MODEL: SR1/SR3

FUEL RAIL FIXING

PRIORITY –HIGH (ACTION)

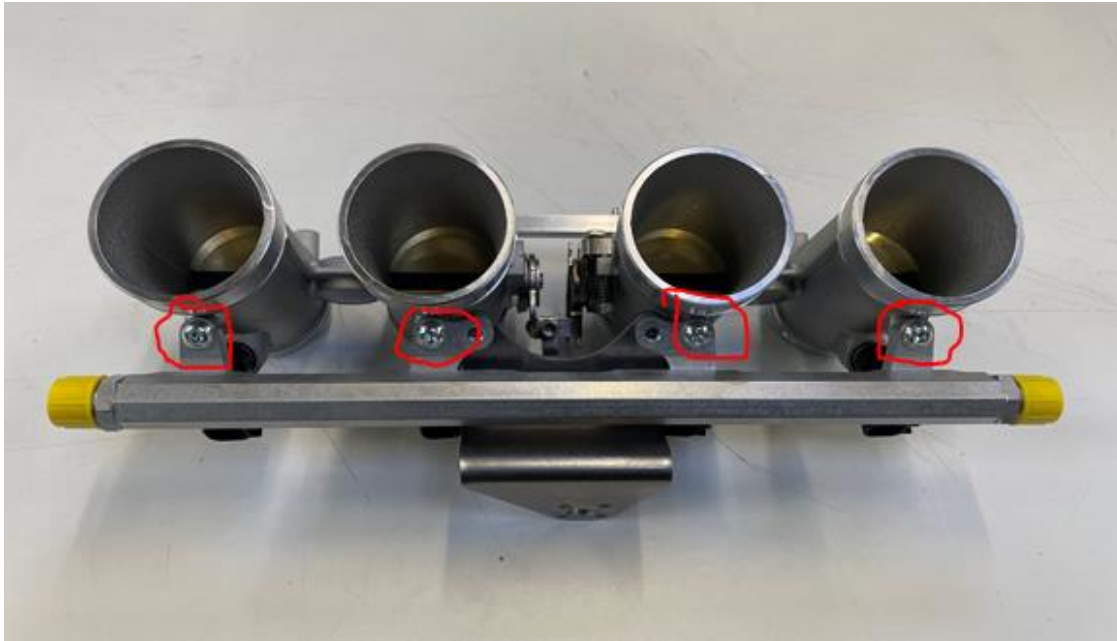
Following an assembly issue from one of our suppliers, all customers are advised to check the fixing of the Fuel Rail bolts.

As a precaution it is advised to check all cars delivered since January 1st 2022.

Step 1 - Undo one fuel rail mounting screw with the 4mm Hex key - check for blue Loctite.

Step 2 – If no Loctite is found, Loctite 243 to M6x12 button head (thread end). Screw in and torque to 7Nm.

Step 3 - Repeat for all 4 Bolts
